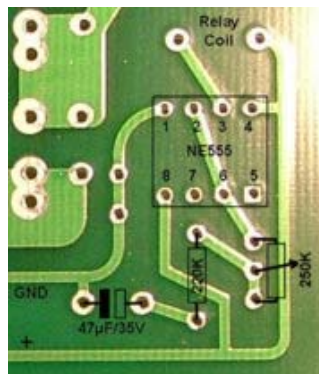
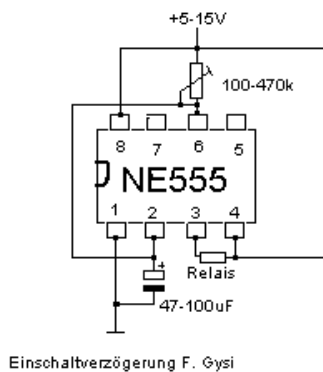
I populated the board with all the necessary components and when I fired up the Power Supply board it came to my attention that the relay didn't activate after the approximate proposed 20 seconds. First I thought it was a faulty relay but when I applied power to the coil it worked. Next in line was the timer IC that might be the culprit, Franz assured me that these things are quite sturdy and therefore hard to believe that this was the cause of the malfunctioning of the circuit. I replaced it anyhow with another one but without any luck. Only when I started comparing the PCB traces with the wiring diagram it dawned on me that the layout on the circuit board is wrong.

As you can see in the above images there are some differences. On the left is Franz's circuit, on the right the actual PCB layout. The left image shows you that the 47µF capacitor is connected between ground and pin 2 (6) of the timer IC and that the resistor (or trimmer) is connected between +VCD and pin 6 (2) of the timer relay. On the PCB the capacitor goes from ground in series with the resistor to pin 6 of the timer relay. Get the picture!
